SUBDIVISION STAFF REPORT Date: April 1, 2004

DEVELOPMENT NAME Windham Place

SUBDIVISION NAME Windham Place Subdivision

SITE PLAN

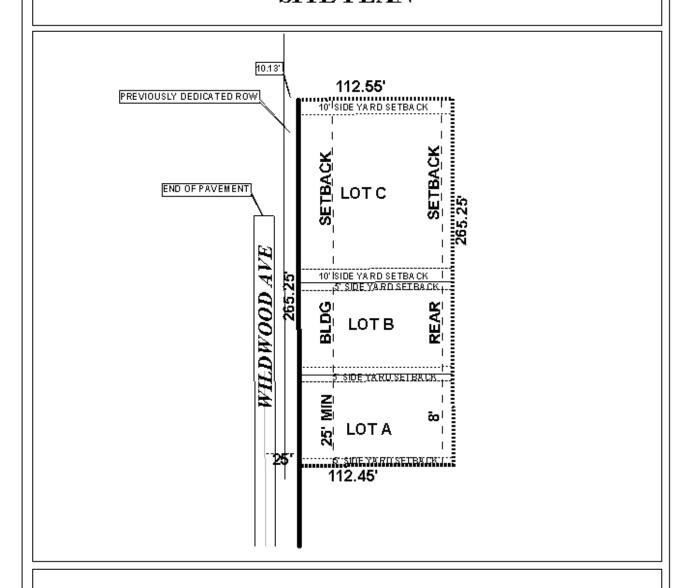
REMARKS The applicant is proposing development of the site as a three lot residential subdivision, with two lots having reduced side yard setbacks of 5' each.

Typically when an application for a residential PUD with reduced setbacks is presented, it is for a much larger, self-contained development with reduced lot sizes. In this instance, the subdivision involved is a three lot resubdivision of a single lot of record. The two lots for which the reduced setbacks are proposed are 66.3' in width, which exceeds the 60' minimum required by the Subdivision Regulations and upon which the minimum setbacks of the Zoning Ordinance are based.

Additionally, the South side setback of Lot A, which is proposed at 5', would be adjacent to property that is not a part of the PUD. Generally, reduced setbacks are only from interior lot lines and are not located adjacent to properties which are not included in the PUD.

The property to the South is the remainder of the resubdivision that created the property in question. The lots in that subdivision are similar in size to the lots proposed and did not propose or require reduced setbacks.

Given the scope and scale of the proposed development, it would not be considered an innovative or cohesive development plan, and thus not appropriate for consideration under the PUD section.

RECOMMENDATION Planned Unit Development: based on the preceding, it is recommended that this application be denied.

Subdivision: based on the preceding, it is recommended that the plat be granted Tentative Approval.
